PRIMROSE SCHOOL

**Re: Storm Water Inspection at Primrose School
Permit # 4Gc02653*AG**

Figure 1

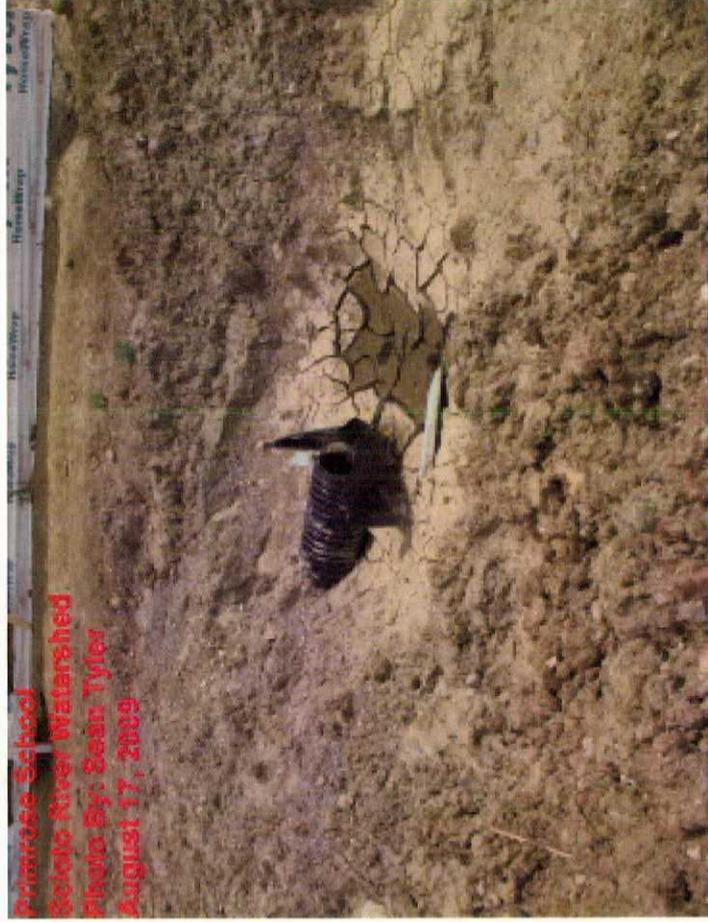
- The perimeter silt fence along the eastern side of the site has failed and will require maintenance at this time.
- The inlets within the site do not have adequate protection at this time (See Figure 1 and 2). Please install the proper protection devices and ensure they are working as intended or demonstrate an approvable alternative
- Please be aware that the General Permit indicates that all sediment controls will be inspected and maintained every seven days or within 24 hours of a precipitation event equal to or greater than 0.5 inches. A log of inspection must be maintained on site for the agency to review.
